ADDENDUM No. Three (3)

IFB No. 2021-014

CONSTRUCTION, COLLIN COUNTY JUVENILE DETENTION, VIDEO RETROFIT

DATE: JANUARY 12, 2021

**1 SITE PLAN**  
ES1.00 SCALE: NOT TO SCALE

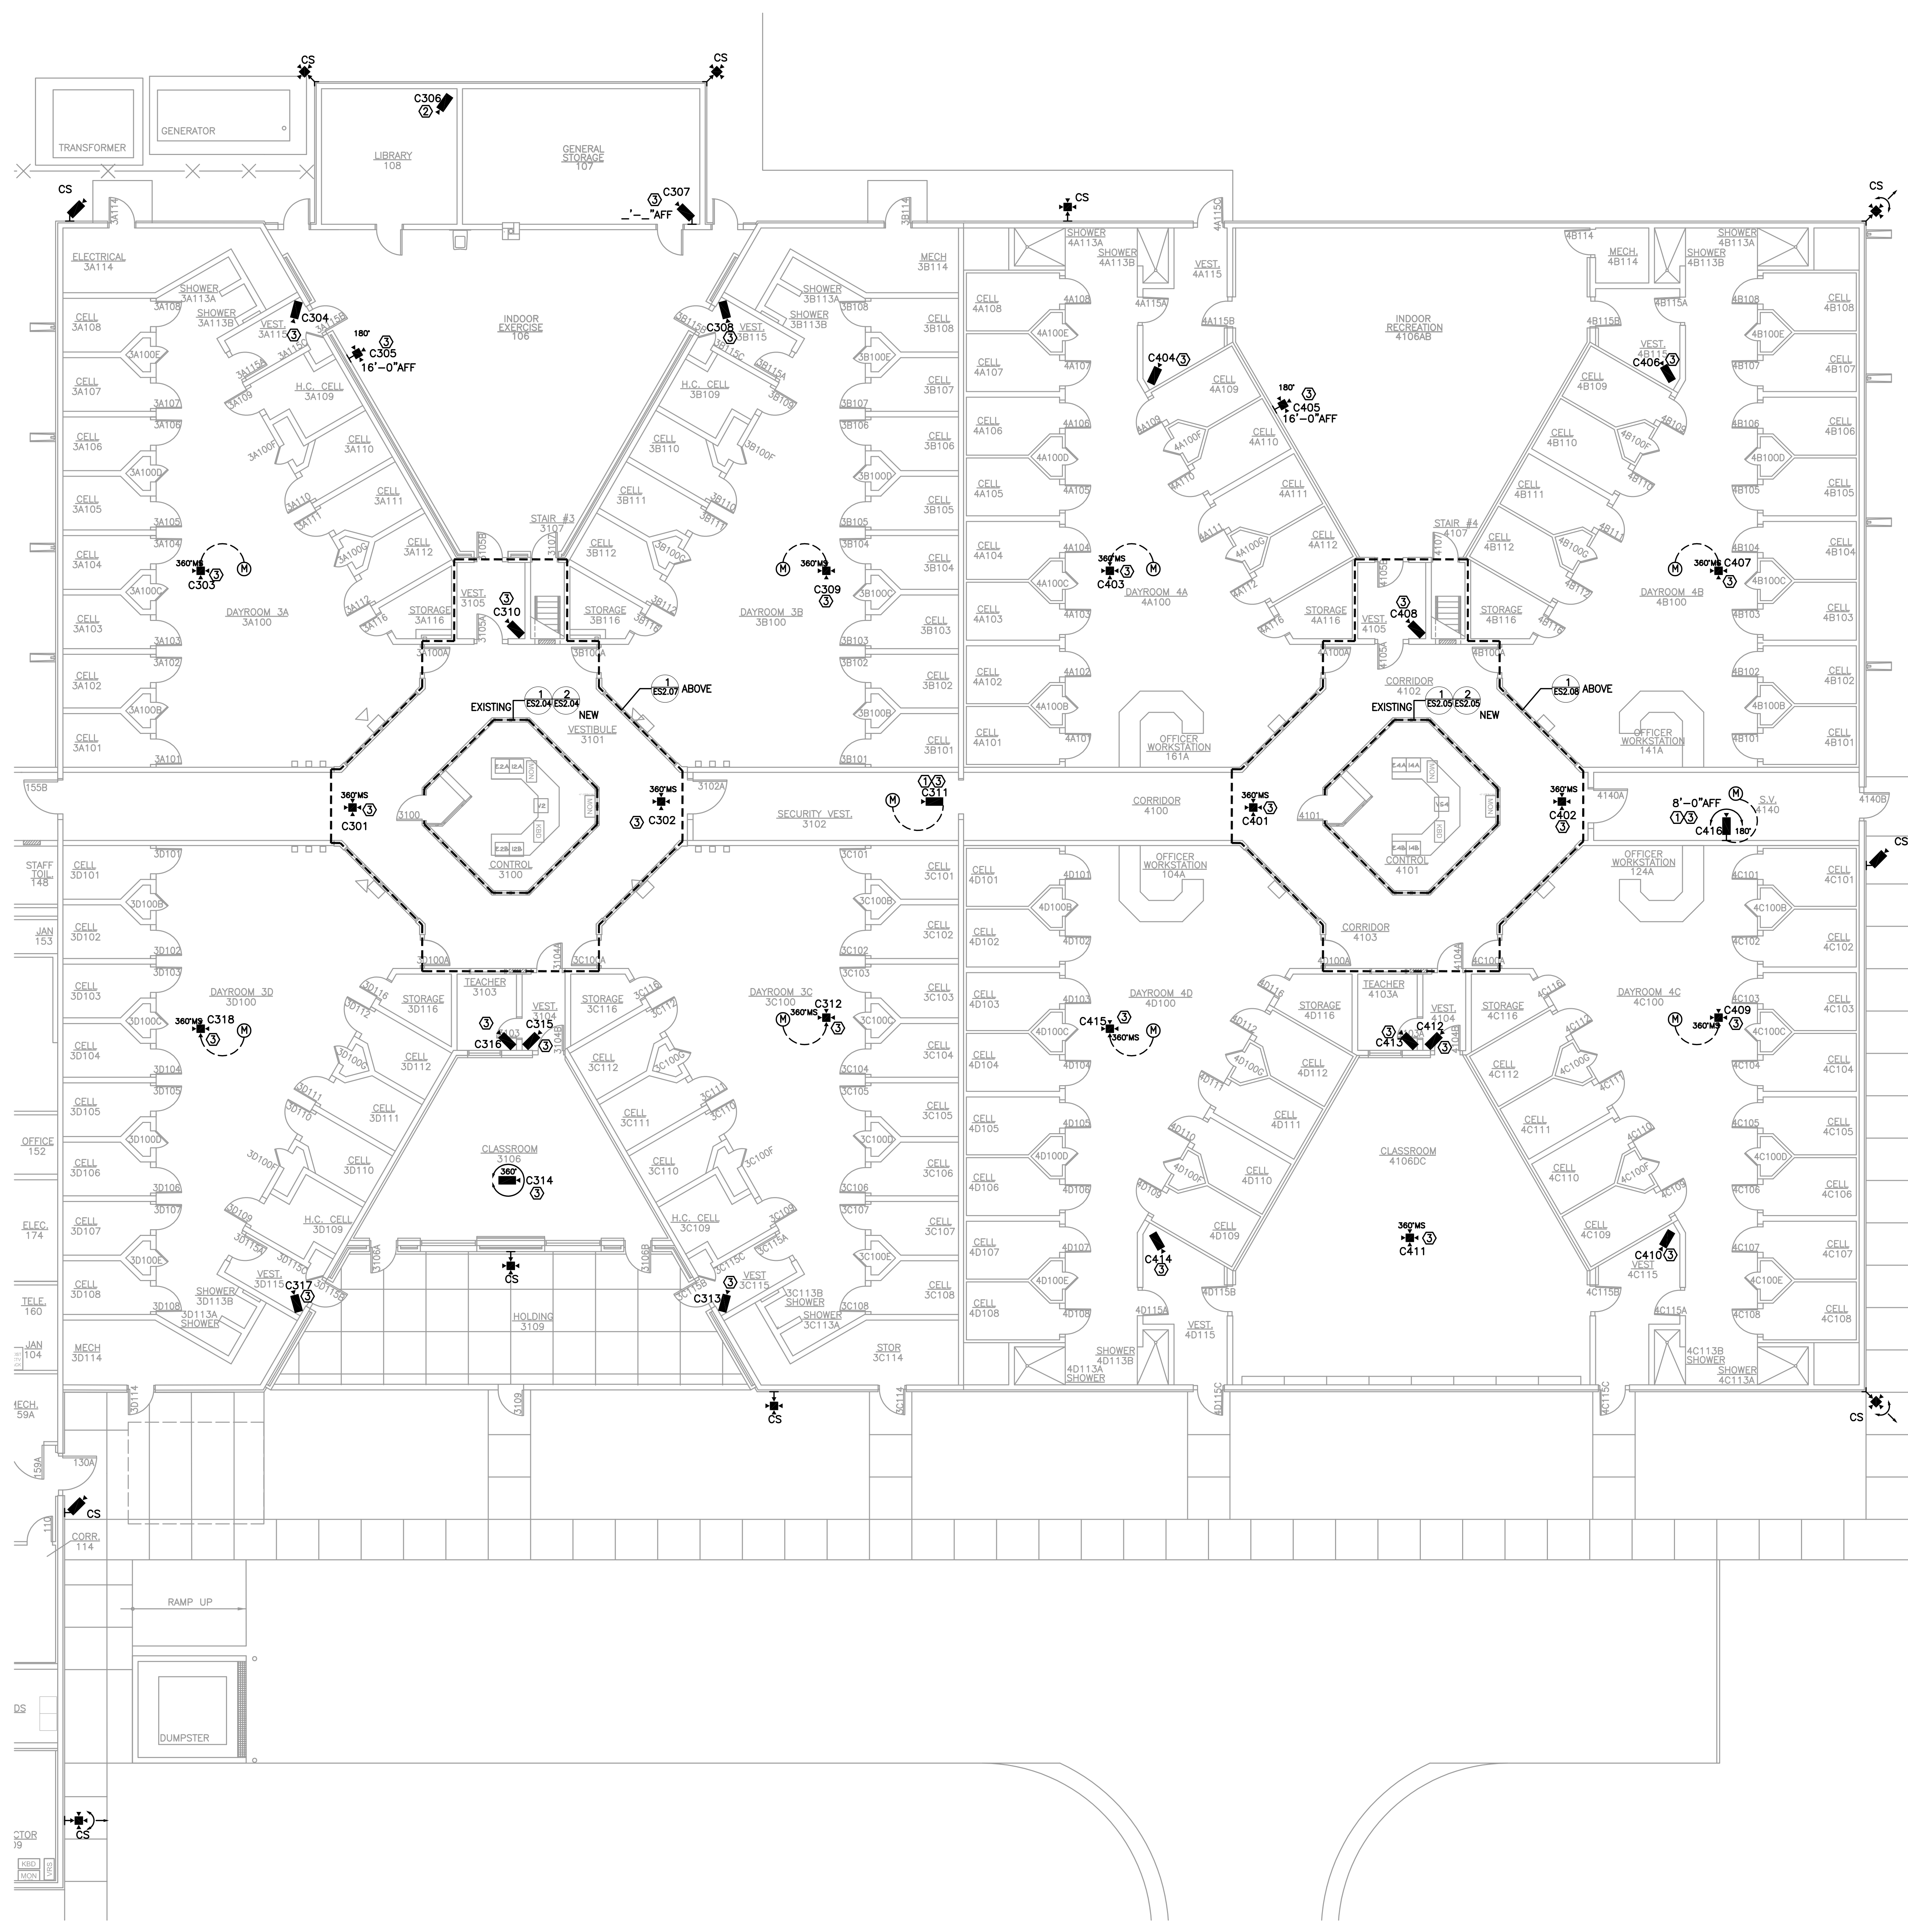
14. Collin County will provide the pathway to the four cameras located on the east perimeter fence. There will be conduit with pull boxes and string for the contractor to pull the necessary cabling. Refer to Addendum 3, Drawing ES1.00 Addendum #1

**1 EXISTING CONTROL ROOM #2100 PLAN**  
 ES2.01 SCALE: 1/2" = 1'-0"

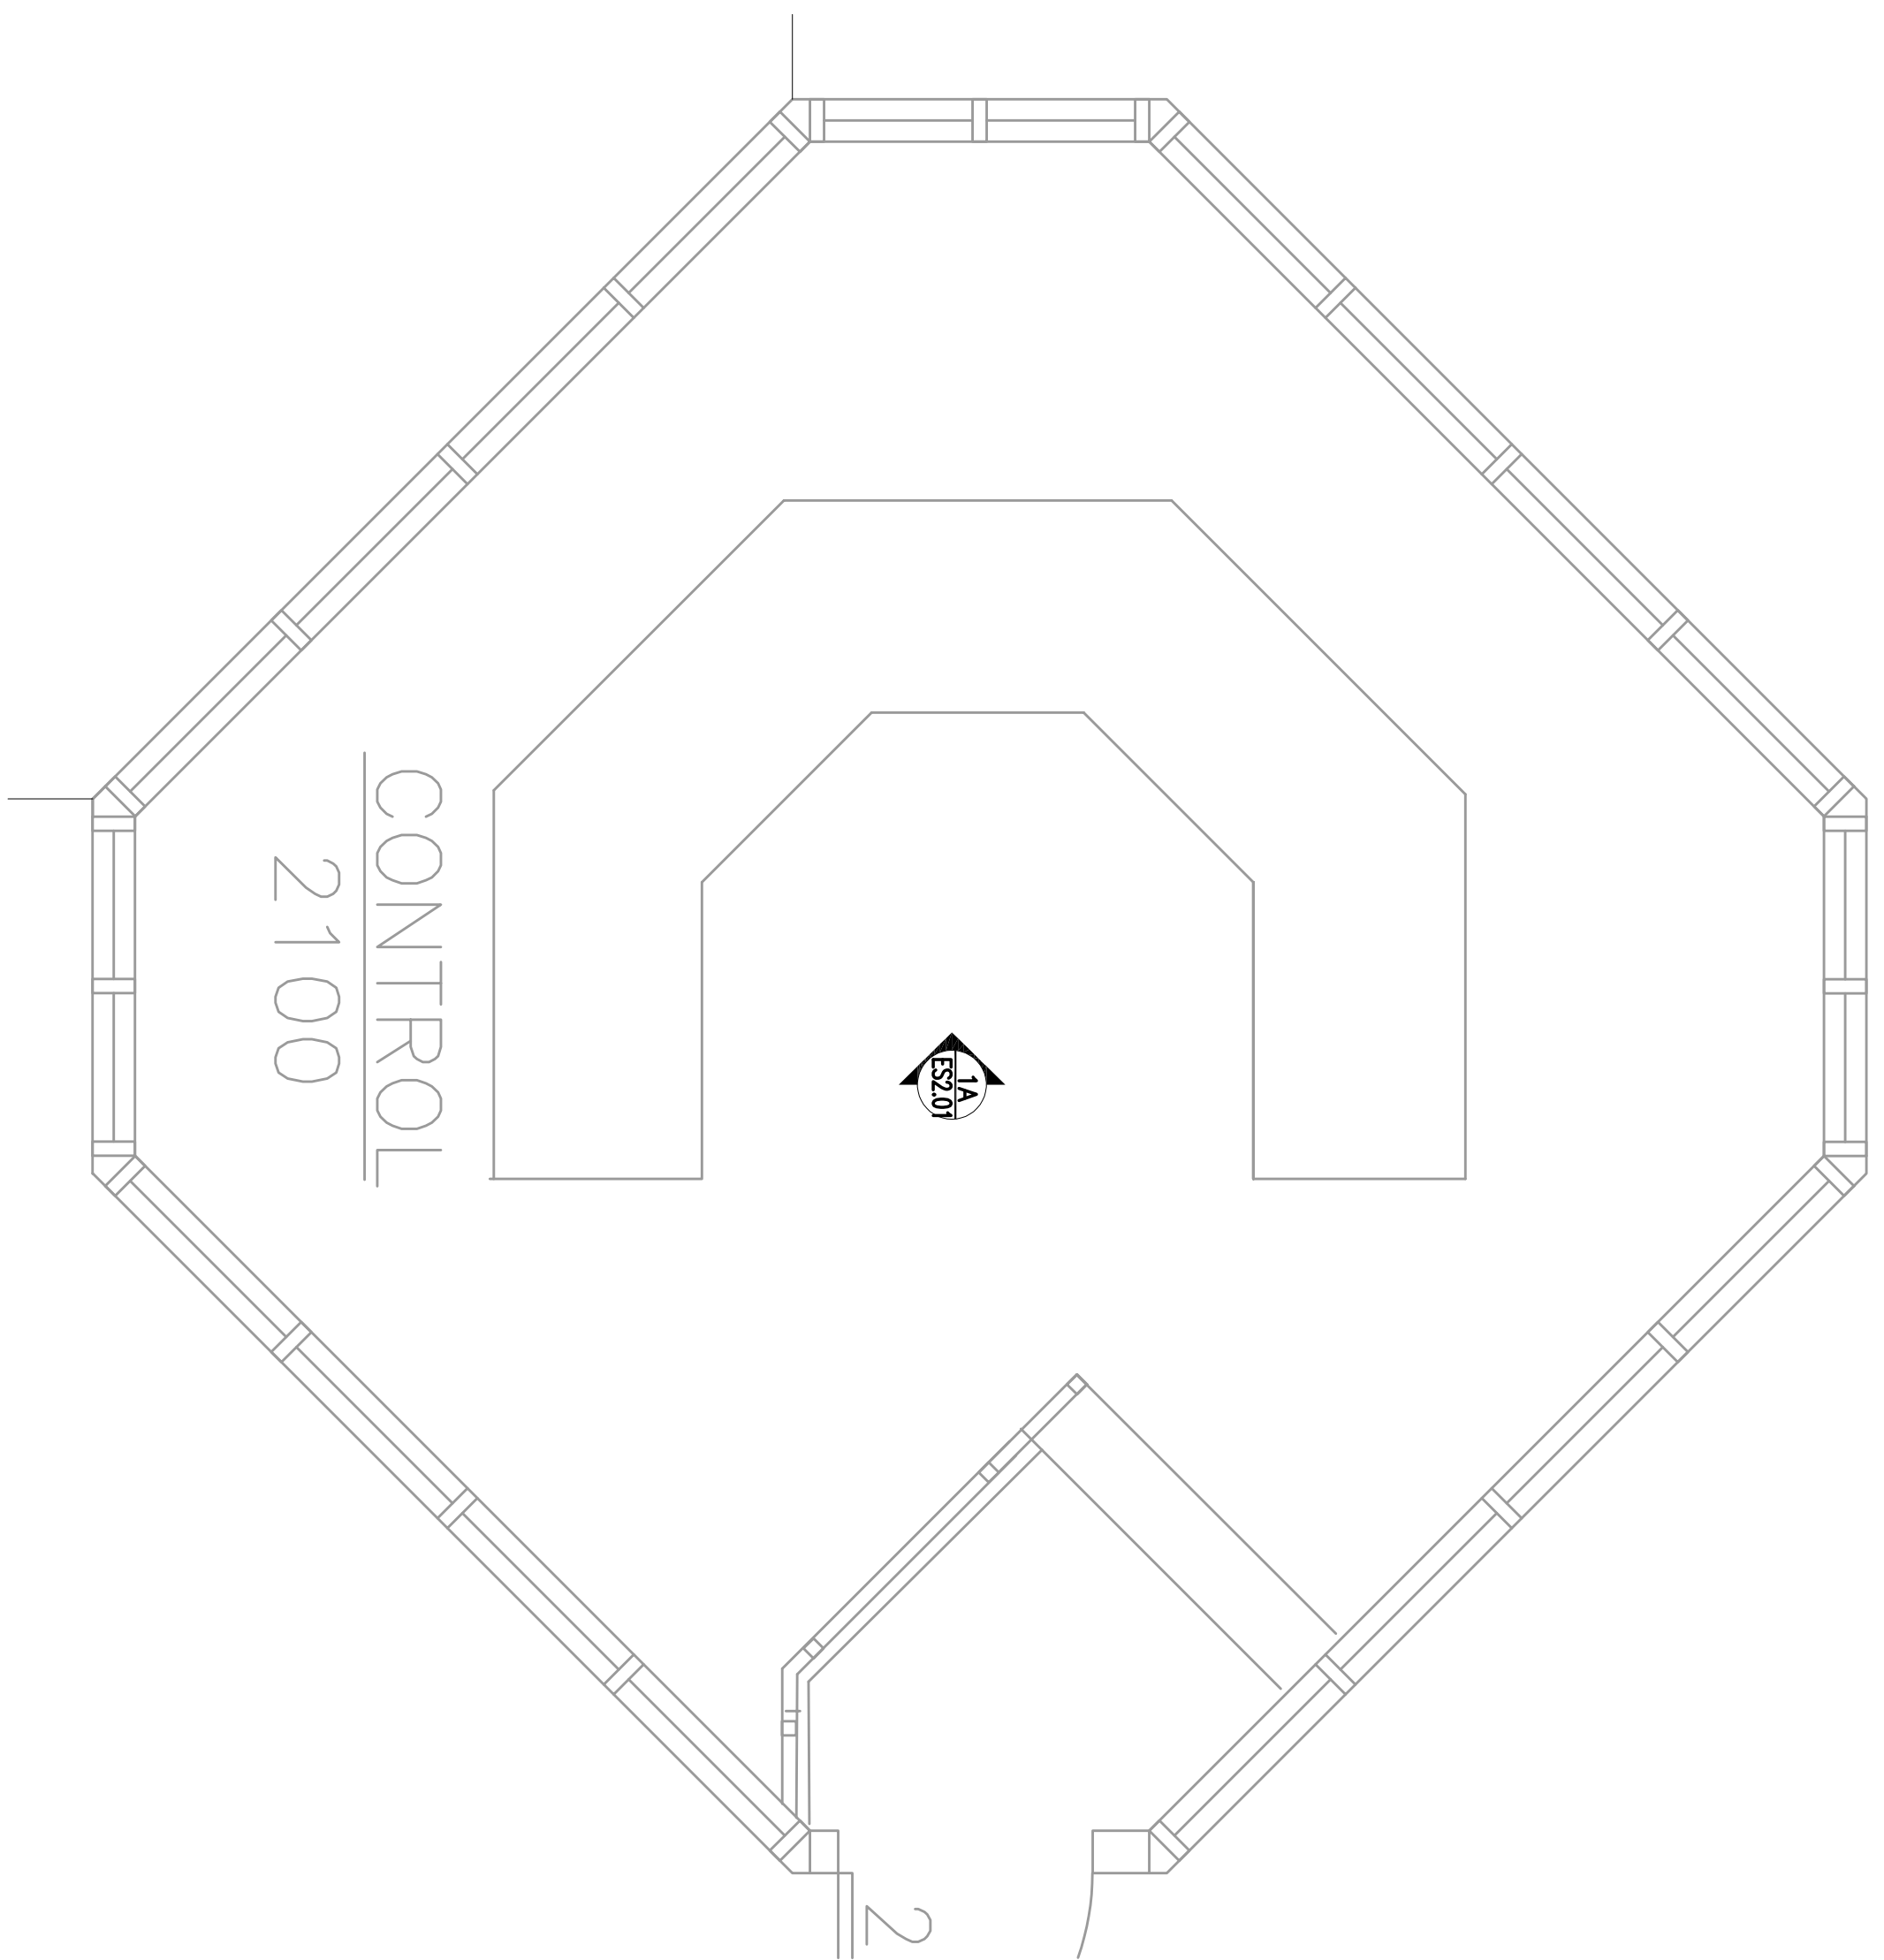
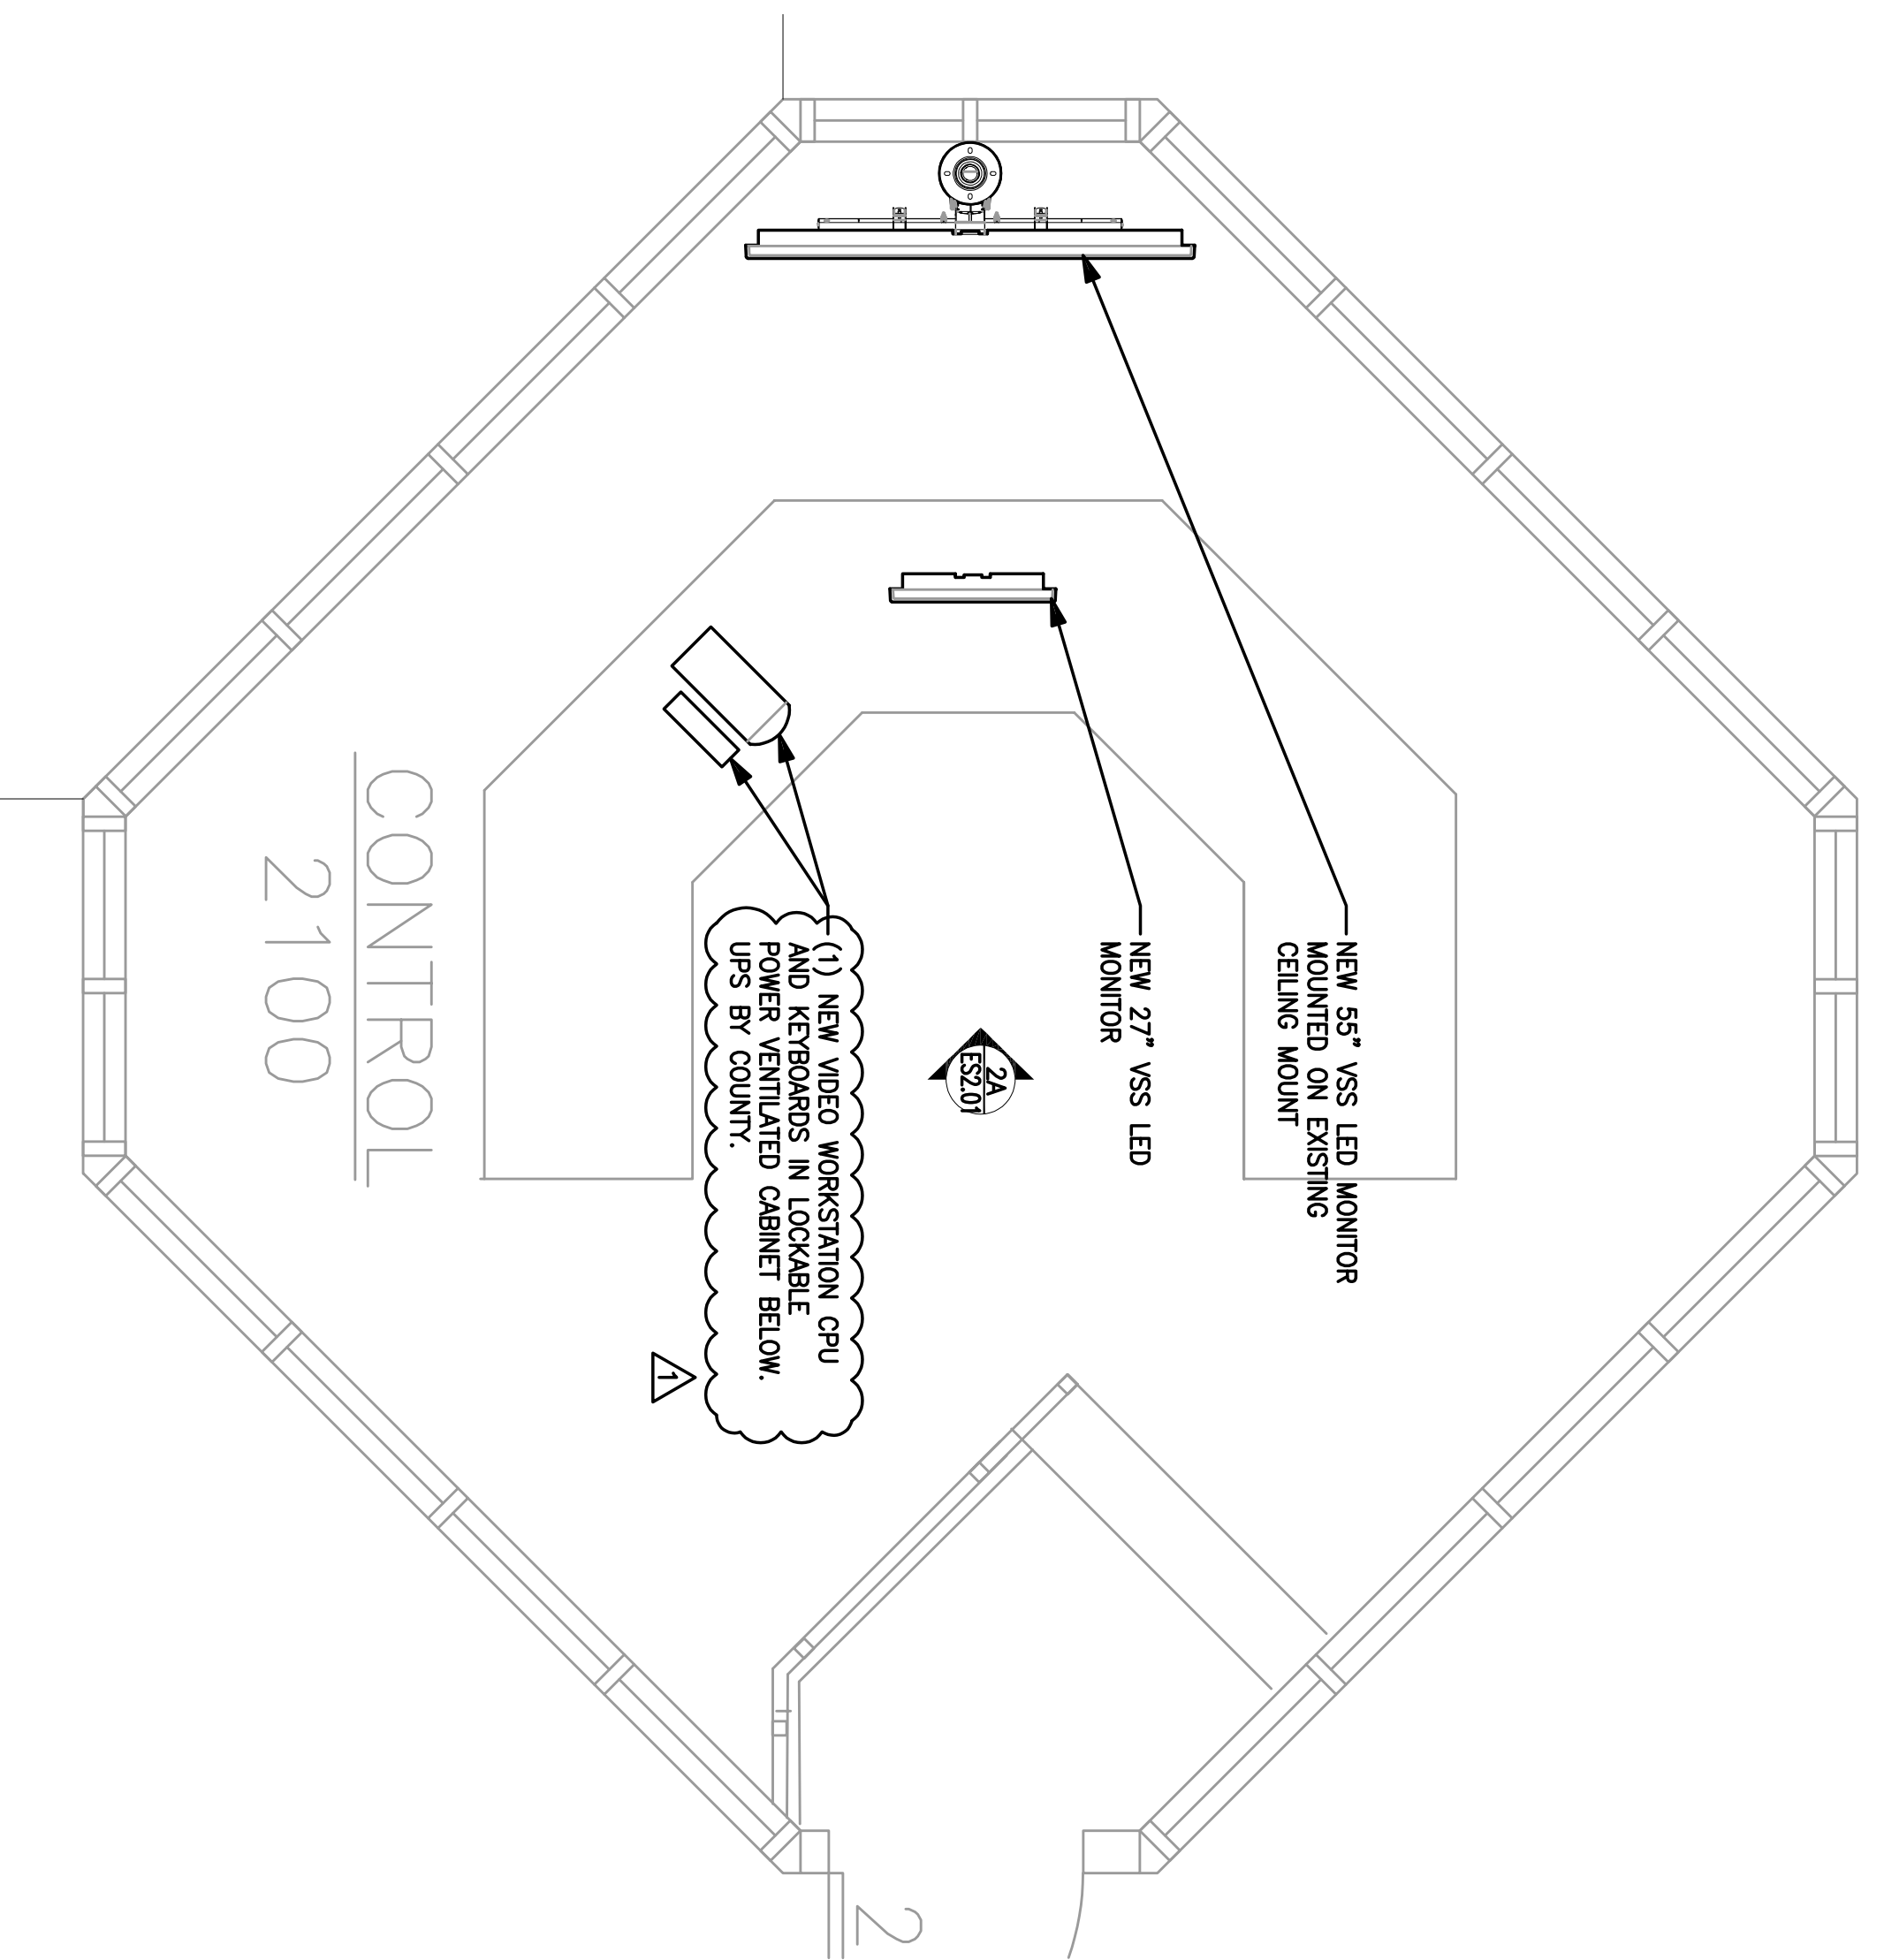
- NOTES:**
1. REMOVE EXISTING CCTV VIEWING EQUIPMENT AND RETURN TO OWNER.
